Environmental Minor Project Refinement Form

Project Name: West of Devers Upgrade Project	Request Prepared By: Sylvia Granados		
Date Approval Required: <u>11/26/2018</u>	Variance Request No.: 22		
Date Submitted: <u>11/19/2018</u>	Location: Barton Road and Mountain View Avenue, in the		
City of Loma Linda; Noble Creek Park in the City of Beaumon	<u>t.</u>		
Landowner: <u>See Description of Change and Justification Section below</u> Landowner Parcel Number: <u>NA</u>			
Current Vegetative Cover/Land Use: <u>Developed/Disturbed</u>			
Existing Sensitive Resource? NO ■ YES Specify: <u>SKR suitable habitat to the north of Noble Creek impact area</u>			
Modifying (check as many as apply): ☐ MITIGAT ☐ DRAWIN	TION MEASURE PLAN/PROCEDURE SPECIFICATION IG PERMIT CONDITION OTHER		
Specify Source (e.g., Mitigation Measure B.5): Modification to NTP #3 and NTP #4 Mapping			
Description of Change and Justification (Attach additional sheets if needed.) Attachments:

Switch Removals for the San Bernardino-Redlands-Timoteo 66-kV Subtransmission Circuit Cutover

Devers-Vista OPGW connection from Tower 4S35 through Noble Creek Park to Oak Valley Parkway

FIGURE 1

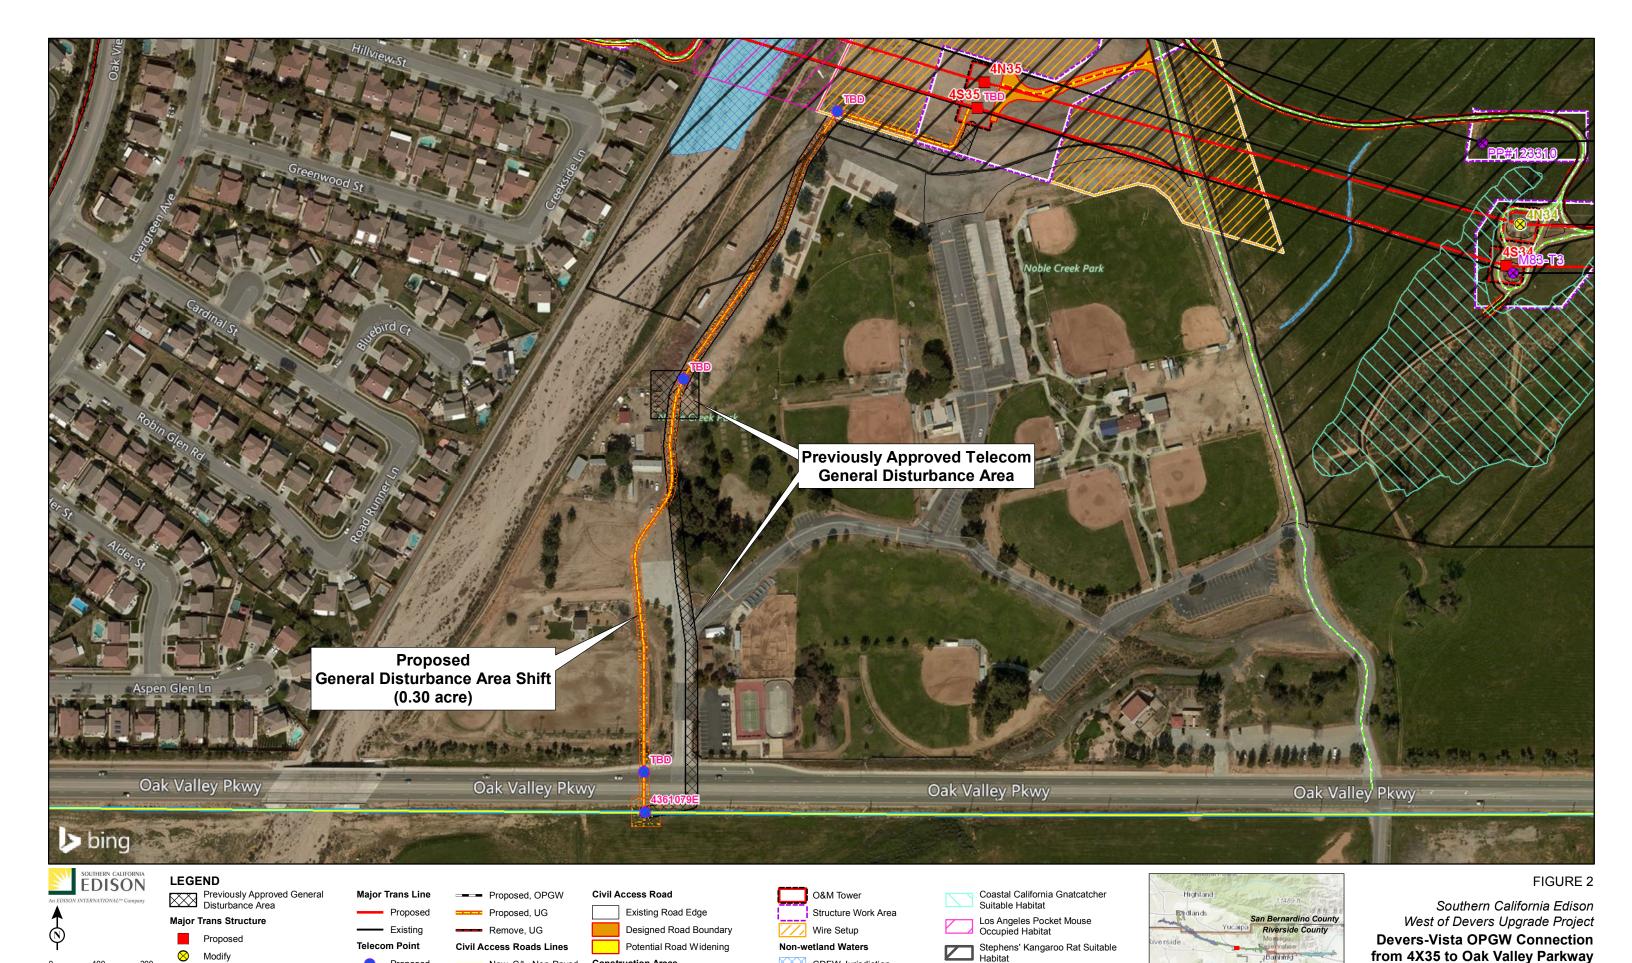
The removal and replacement of one (1) subtransmission pole and two (2) pole mounted switches are required to facilitate the San Bernardino–Redlands–Timoteo 66-kV subtransmission line circuit cutover on Barton Road and Mountain View Avenue in the City of Loma Linda, as shown in Figure 1. The pole and one (1) pole mounted switch will be removed and replaced in the new work area on Mountain View Avenue, north of Barton Road. Grounds will be installed in the work area on Barton Road east of Mountain View, to idle the line and remove a pole mounted switch.

The total temporary work area associated with the switch removal work consists of the previously approved TEWS #10 work area and approximately .70 acre of additional paved roadway and concrete sidewalk, owned by the City of Loma Linda.
